Site Accessibility Evaluation

Fire Station 3

**922 W Colorado Ave
Colorado Springs, CO
80905**

SUBJECT: Fire Station 3 Self-Evaluation

Finding: 2

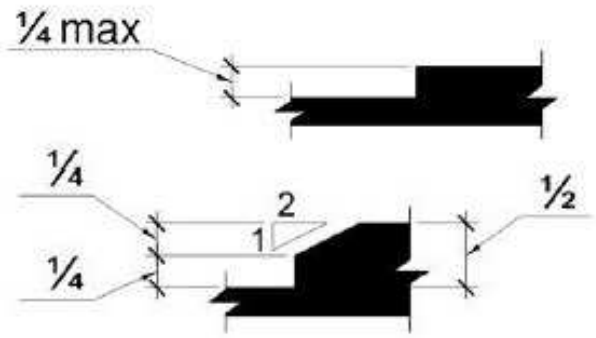
The rear entrance may only be accessed by 2 steps, totalling 14".

This path of travel requires crossing a drainage grate with holes greater than 1/2" in the path of travel.

The walkway contains abrupt vertical edges and/or variations over a 1/4 inch.

The rear entrance is not accessible.

Leave as is, and install signage indicating the front entrance is the accessible entrance.

Finding: 3

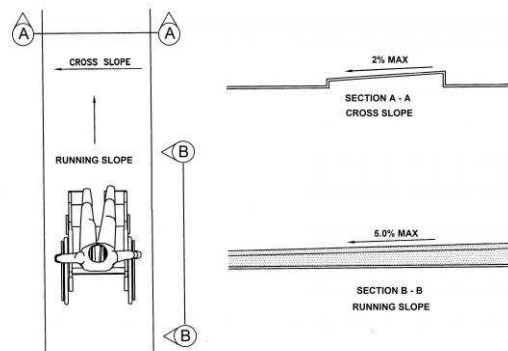
The accessible route of travel between the building and the public way on the site contains cross slopes greater than 2%. The cross slope is up to 6.1% in 11 concrete panels. The sidewalk is 4'-0" wide.

The sidewalk to the front entrance has cross slopes up to 4%.

Remove and replace approximately 11 concrete panels as needed.

Finding: 4

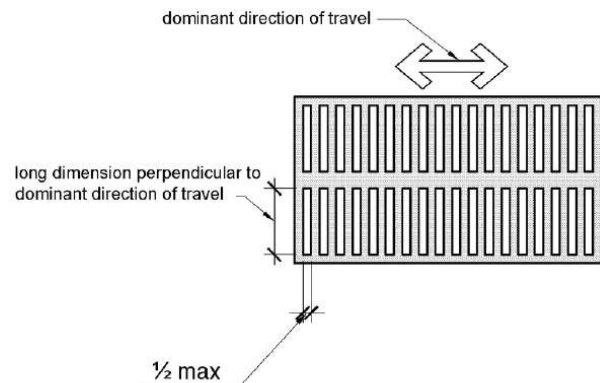
The concrete expansion joint is spaced greater than a 1/2 inch. Four concrete panels are affected.

The sidewalk to the front entrance has 1/2" gaps.

Replace the concrete panels.

Finding: 5

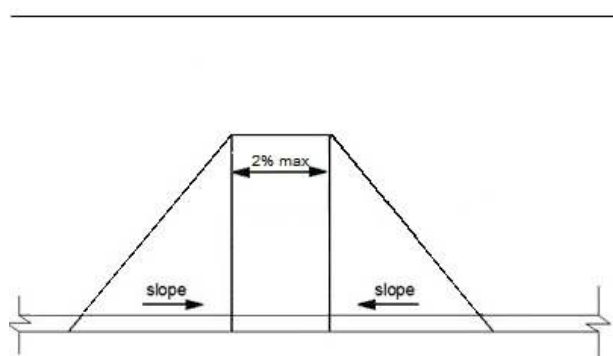
The curb ramp on the accessible route contains cross slopes greater than 2%.

Another issue is that it lacks detectable warnings.

The cross slope of the landing at the top of the curb ramp is 3.1%.

Replace curb ramp and landing

Finding: 6

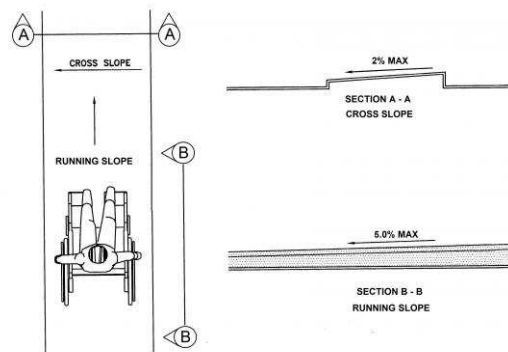
The accessible path of travel contains cross slopes greater than 2%.

The cross slope of the accessible route in the driveway is up to 7.5%.

Remove and replace the paving as much as feasible to try to obtain maximum 2% cross slope.

Finding: 7

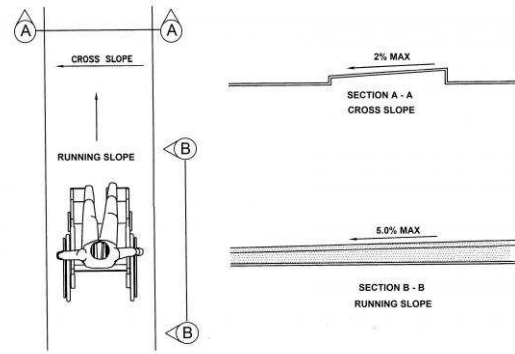
The accessible route contains running slopes greater than 5 percent across the width of the walk and has not been constructed as a ramp (i.e. handrails, wheel guides, etc.). The driveway has running slope up to 6.3%.

There is not an accessible route from the public way to the front entrance.

Create an accessible route from the sidewalk to the entry of the building. It either needs to be angled to create an accessible route under 5% or we need a ramp with provisions if adjacent to the driveway.

Finding: 8

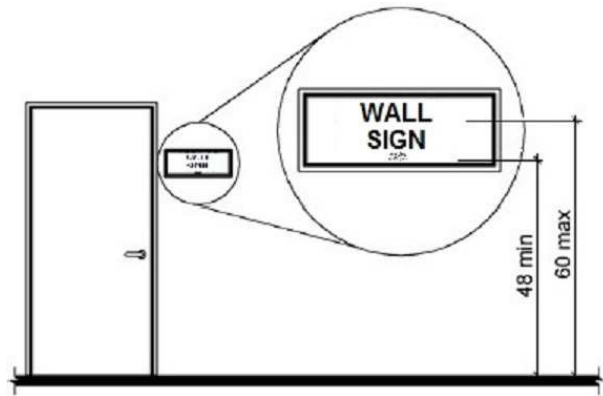
The door bell is small and difficult to see.

Compliant room identification signs are missing on the strike side of the door.

There is not a sign at the door bell.

Add signage.

Finding: 9

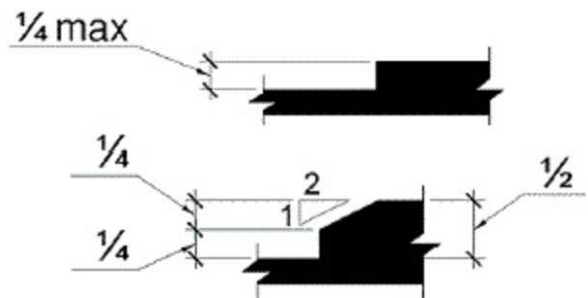
The threshold has a vertical change greater than 1/4 inch high.

The threshold at the front door has a lip ranging from 1/4" to 3/8".

Explore method to level out the threshold.
